TECHNICAL BULLETIN

FAM-A-0012-A

Change to the Label on MELSEC-F Series Battery FX2NC-32BL

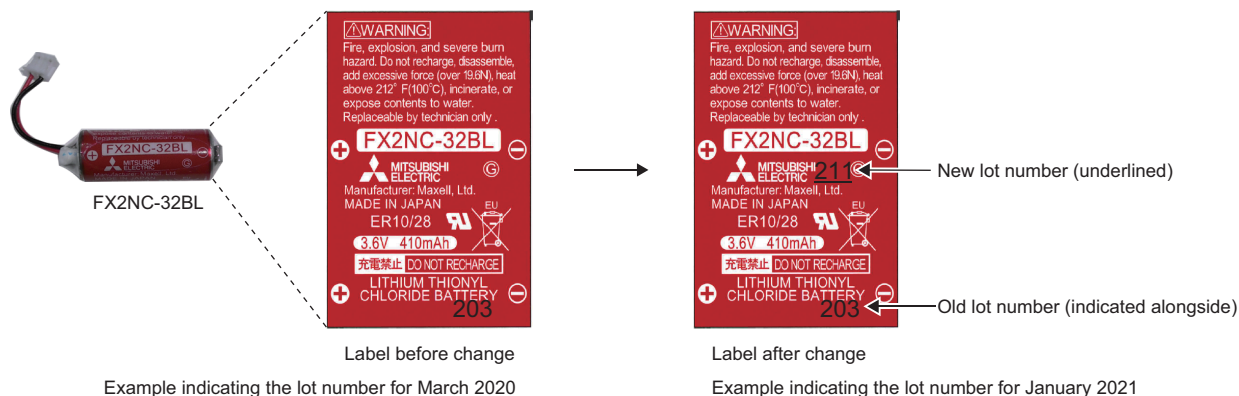
3 DETAILS ON THE CHANGE

A new lot number is added on the label after final inspection before shipment as follows.

After this change, the manufacturing date for the fee warranty period is indicated by the added "new lot number" (underlined).
